**RE: ENV-2002-2481-EIR; SCH#2002091918 Canyon Hills Project - DEIR Comments**

**Section IV Environmental Impact Analysis-  
Sub-section F: Artificial Light and Glare-**

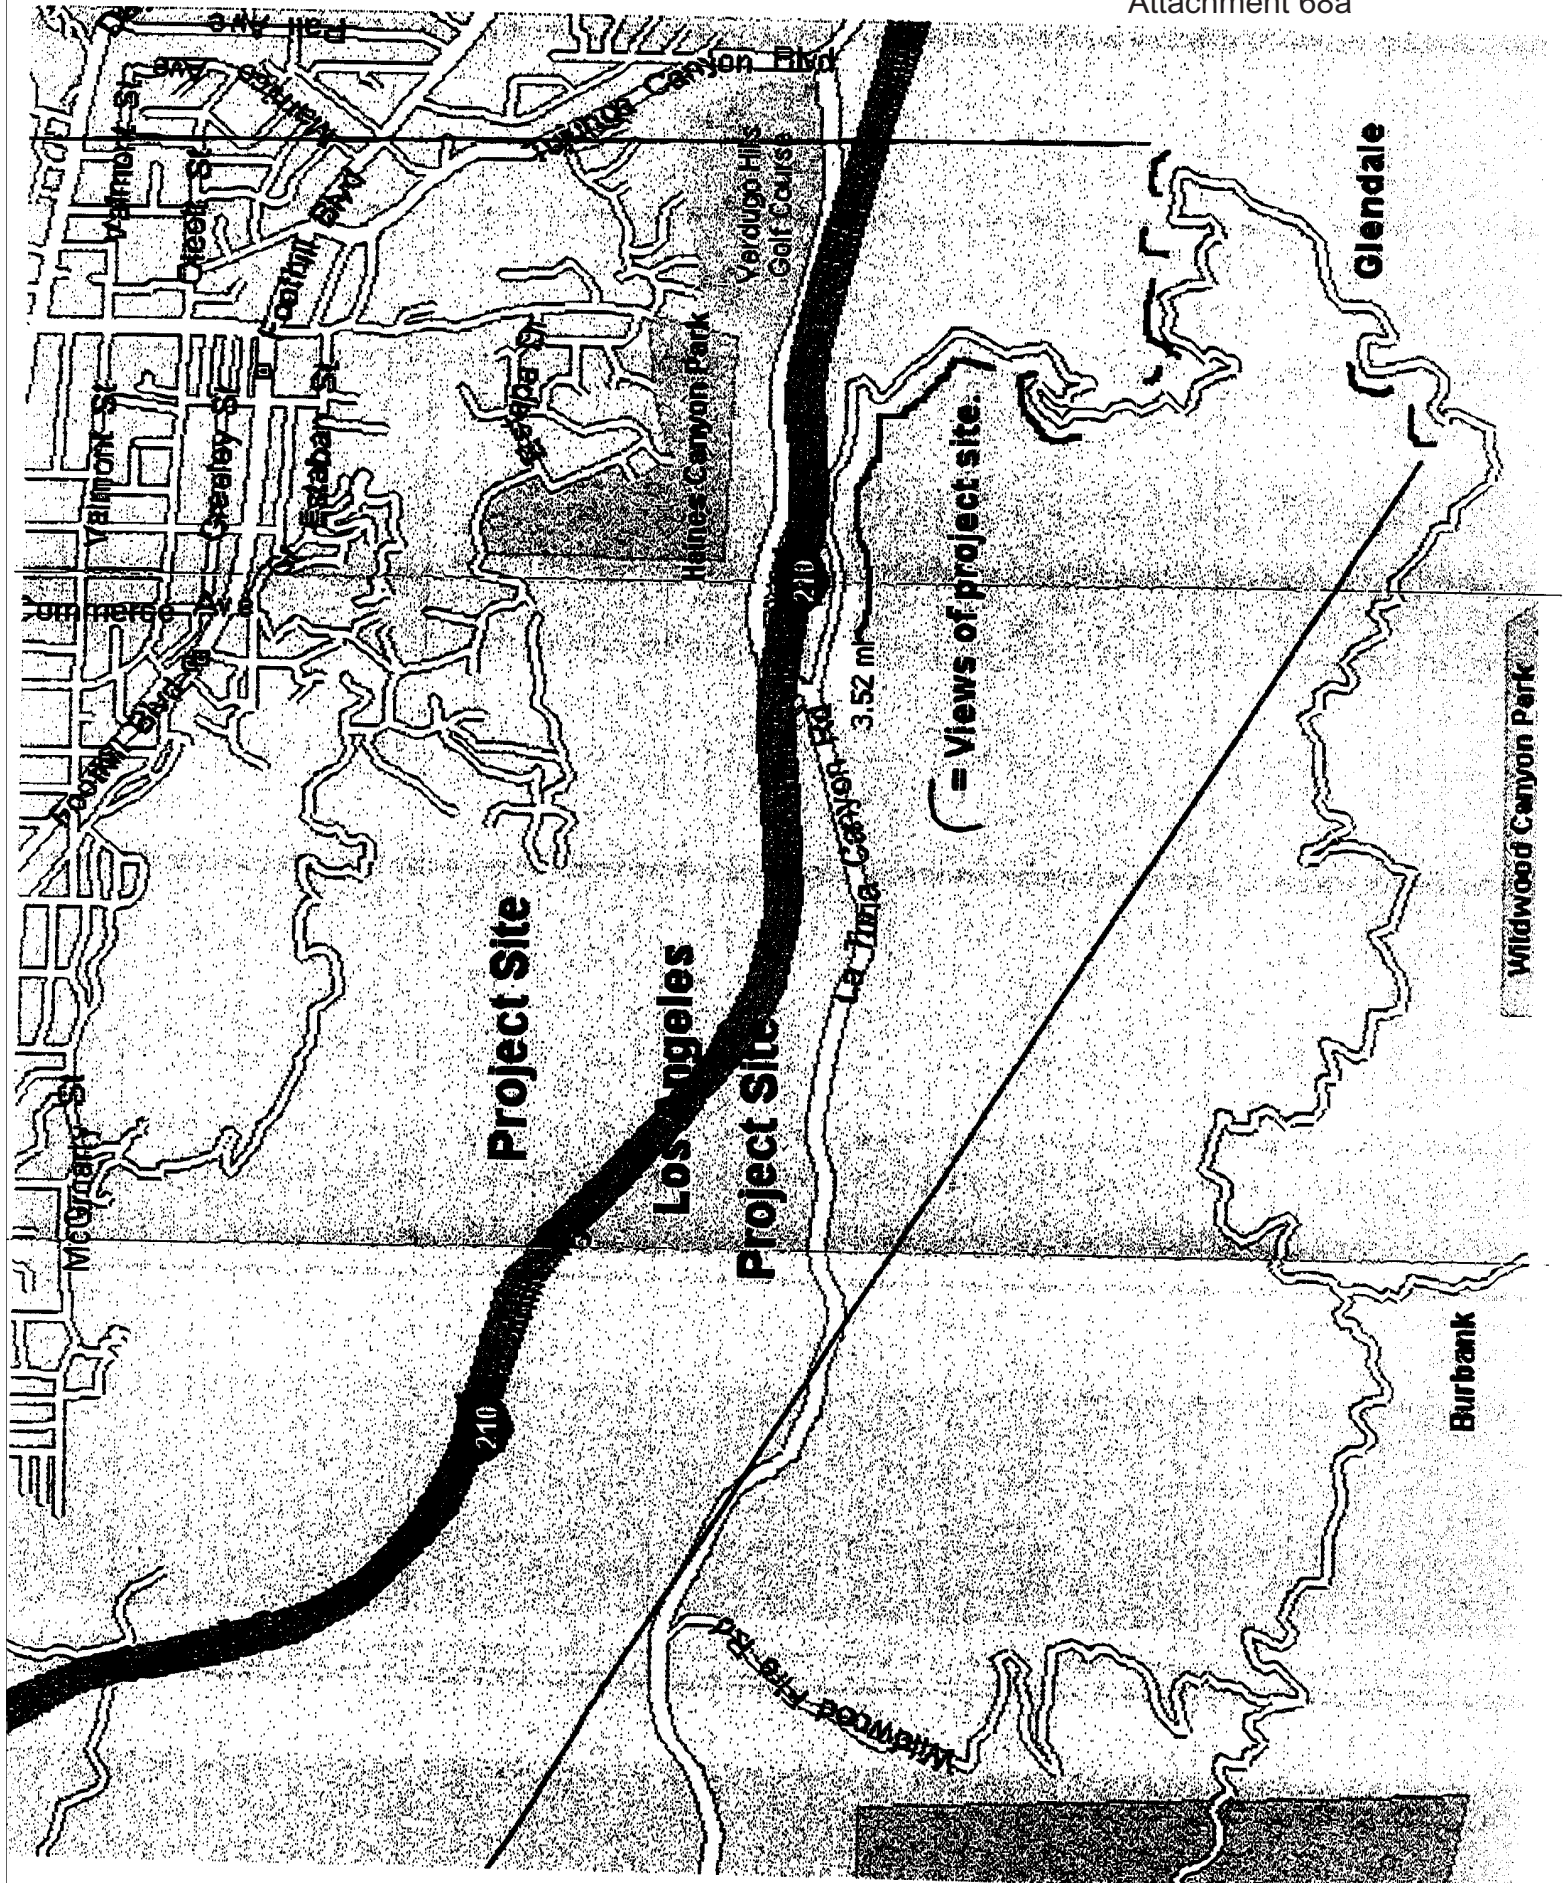
As one of several dozen mountain bikers in the area, I must bring to your attention the fact that night biking is quite popular on Hostetter Mtwy year round. There are several groups and riders that descend Hostetter on any given weeknight after dark. As well; over the last three years, in warmer months, I have witnessed increased numbers of hiking groups ascending and descending this same road. Hostetter is much more popular at night than what the report indicates. The project site makes up a very large part of the view while descending Hostetter from Verdugo Mtwy especially past the 1.00mi mark along the last 2.5mi till the trail head at La Tuna Canyon Rd. *The DEIR is in ERROR by omitting details of this in the Artificial Light and Glare section.*

Currently these views from Hostetter have little nighttime Light Pollution from the project site or surrounding streets, roads and freeways. Night time views of the sky with lower levels of Brightness and Glare are one of the qualities residents currently enjoy that live near the project site. This includes those increasing numbers of people descending Hostetter at night. *If the project site were to be developed as requested, the resulting increase of night time Light Pollution, Glare and Brightness would have a devastating negative impact on these large views to these residents.*

As the foot note #3 in the DEIR indicates, "...it is unlikely that material numbers of the public hike those hillsides at night." The dozens of riders and hikers that hike those hillsides at night expose this as untrue and the report needs to be corrected to reflect the growing popularity of Hostetter Mtwy at night.
